CERTIFICATE OF APPROPRIATENESS PLACARD

515 CUTLER STREET

BOYLAN HEIGHTS

Minor Work Application - 515 Cutler Street

#1. TREE ENGROPHEMENT ON STUDIO STRUCTURE

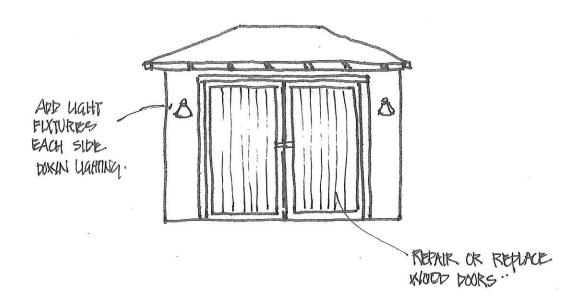
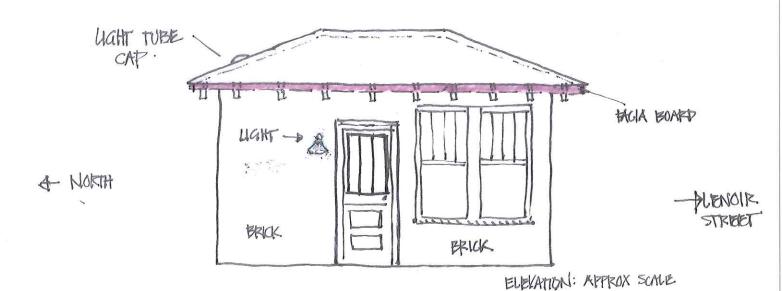
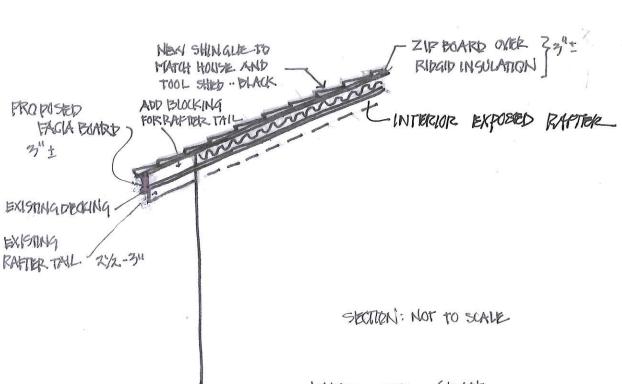
- Please send in specs for the light tube that you mentioned (diameter, how high)
- The changes proposed to the roof of the historic accessory building do not clearly meet the Guidelines and is not approvable by staff. It is an item requiring a determination by RHDC as part of a Major Work application. Please confirm that you would like those changes removed from this Minor Work application.

• The changes proposed to the roof of the historic accessory building do not clearly meet the Guidelines and is not approvable by staff. It is an item requiring a determination by RHDC as part of a Major Work application. Please confirm that you would like those changes removed from this Minor Work application. Yes, please remove the roof changes from the Minor Work application. We will consider an alternative to the proposed changes.

However, as a maintenance item under Minor Work, we may still need to re-shingle the roof. We would use the same shingle type and color (charcoal) as on the house and tool shed. Please keep this portion a part of the application.

RE: Tree Removal 515 Cutler Street, Boylan Heights, Raleigh, NC 27603

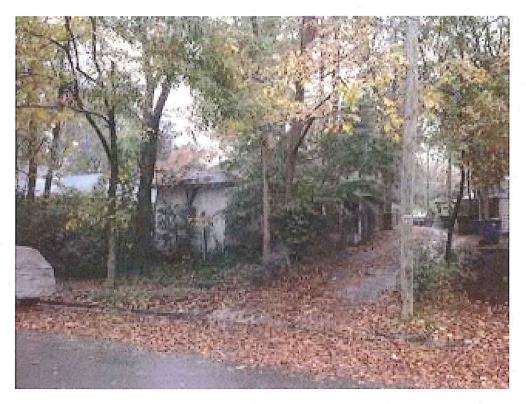
- For the tree removal to be a Minor Work, please send in a letter from a certified arborist attesting to the fact that the tree is dead, diseased or dangerous or damaging historic property and recommending its removal. When a tree is removed, the Guidelines (2.3.5) mandate that it be replaced by a replacement tree of similar or identical species or , per RHDC policy, a fee-in-lieu payment to the NeighborWoods program. Please let us know which you intend to do.

- Also, could you please send in information about the tree's diameter measured at 4 ½ feet above ground level?
- You propose to renovate/replace the shed doors. If replacing, please confirm that the replacements will be of the same design, dimensions and material.

- For the tree removal to be a Minor Work, please send in a letter from a certified arborist attesting to the fact that the tree is dead, diseased or dangerous or damaging historic property and recommending its removal. Our arborist will supply a letter which I will forward to you. When a tree is removed, the Guidelines (2.3.5) mandate that it be replaced by a replacement tree of similar or identical species or , per RHDC policy, a fee-in-lieu payment to the NeighborWoods program. Please let us know which you intend to do. We would prefer planting a tree. What is the fee-in-kind?

- Also, could you please send in information about the tree's diameter measured at 4 ½ feet above ground level? The diameter is 14" at 4 1/2' above ground level.

The primary reason for recommending this tree's removal is the trunk is now within 6 inches of the roof and roots threaten the foundation wall of the historical garage building at 515 Cutler St. In order to preserve the longevity of this structure, it will be critical to remove this large species Oak tree, preventing its strong and invasive root system from damaging the foundation.
